PHAP25-00043

Date: January 8, 2026
Application Type: Certificate of Appropriateness
Property Owner: Liana Archuleta
Representative: Ricardo Arguelles
Legal Description: 18 Sunset Heights 6 & S 1/2 Of 7 (4500 Sq Ft), City of El Paso, El Paso County, Texas
Historic District: Sunset Heights
Location: 1114 Fewel Street
Representative District: #8
Existing Zoning: R-4/H (Residential/Historic)
Year Built: 1926
Historic Status: Contributing
Request: Reconsideration of an approved Certificate of Appropriateness for construction of an 8'-0" high fence on property line
Orig. Application Filed: 11/6/2025
Orig. 45 Day Expiration: 12/21/2025

ITEM #1

Reconsideration of an approved Certificate of Appropriateness for construction of an 8'-0" high fence on property line.

ORIGINALLY PROPOSED ELEVATION PLAN

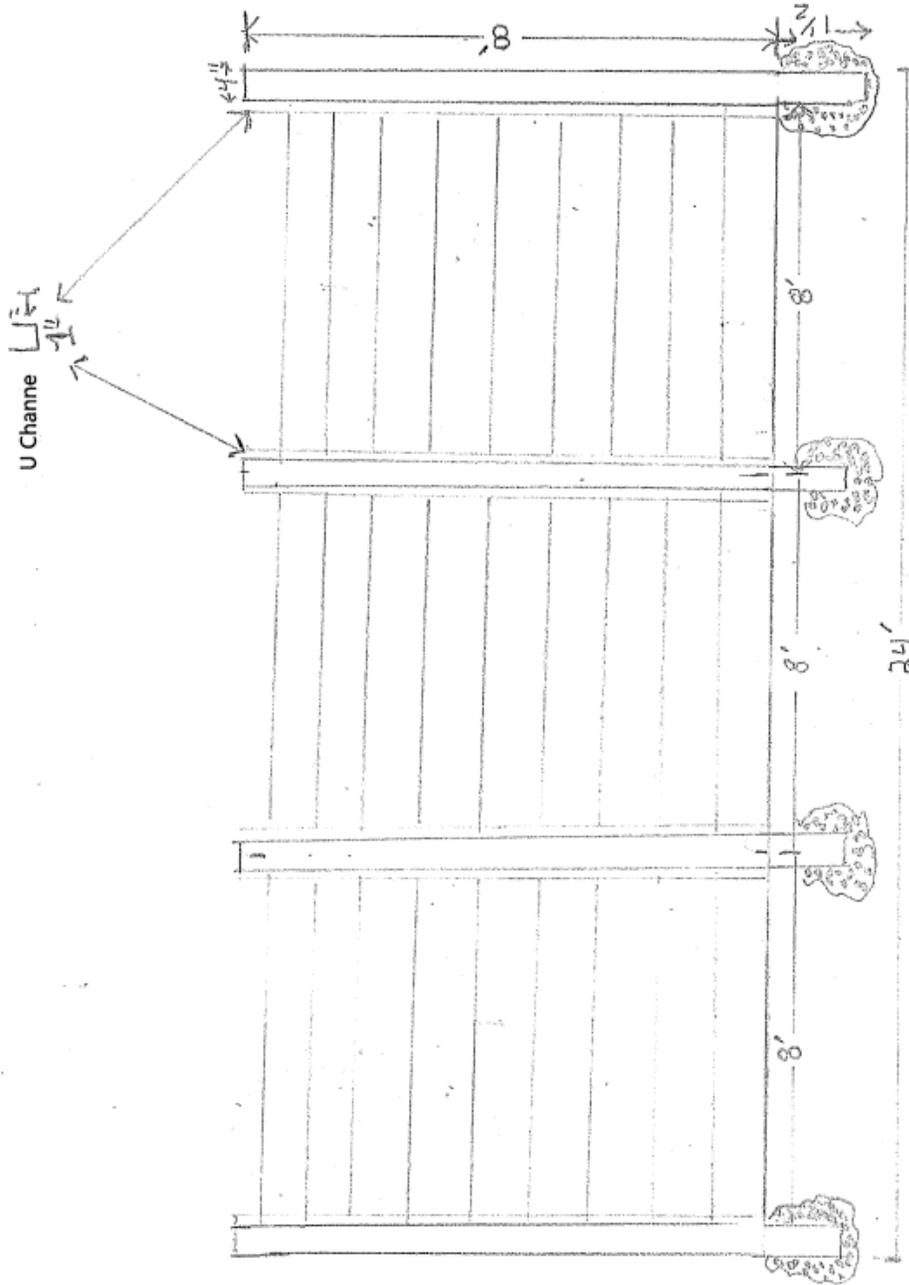
The Historic Preservation Office recommends APPROVAL A MODIFICATION of the proposed scope of work based on the following recommendations:

The modification is that the fence that was approved by the HLC be installed.
